SERVICE BULLETIN

DATE: 23 APRIL 1999

IMPROVED ENGINE TORQUE PRESSURE TRANSDUCER

Figure 1. Pressure Transducer Location

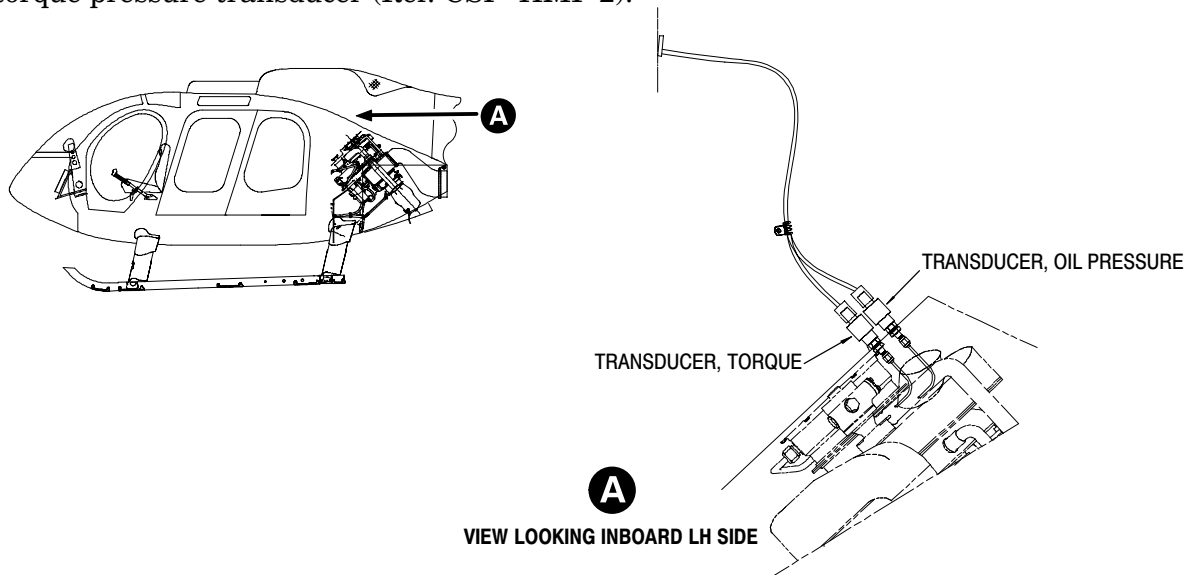
Engine torque pressure transducer P/N PX9606 may indicate slightly higher torque than actual torque. Failure to comply with this Bulletin may result in the pilot receiving incorrect engine torque indications.

- (1). Replace existing torque pressure transducer P/N PX9606 with new P/N PX9606-1 torque pressure transducer (Ref. CSP-HMI-2).

The torque pressure transducer P/N PX9606-1 supercedes and is one way interchangeable with the P/N PX9606.
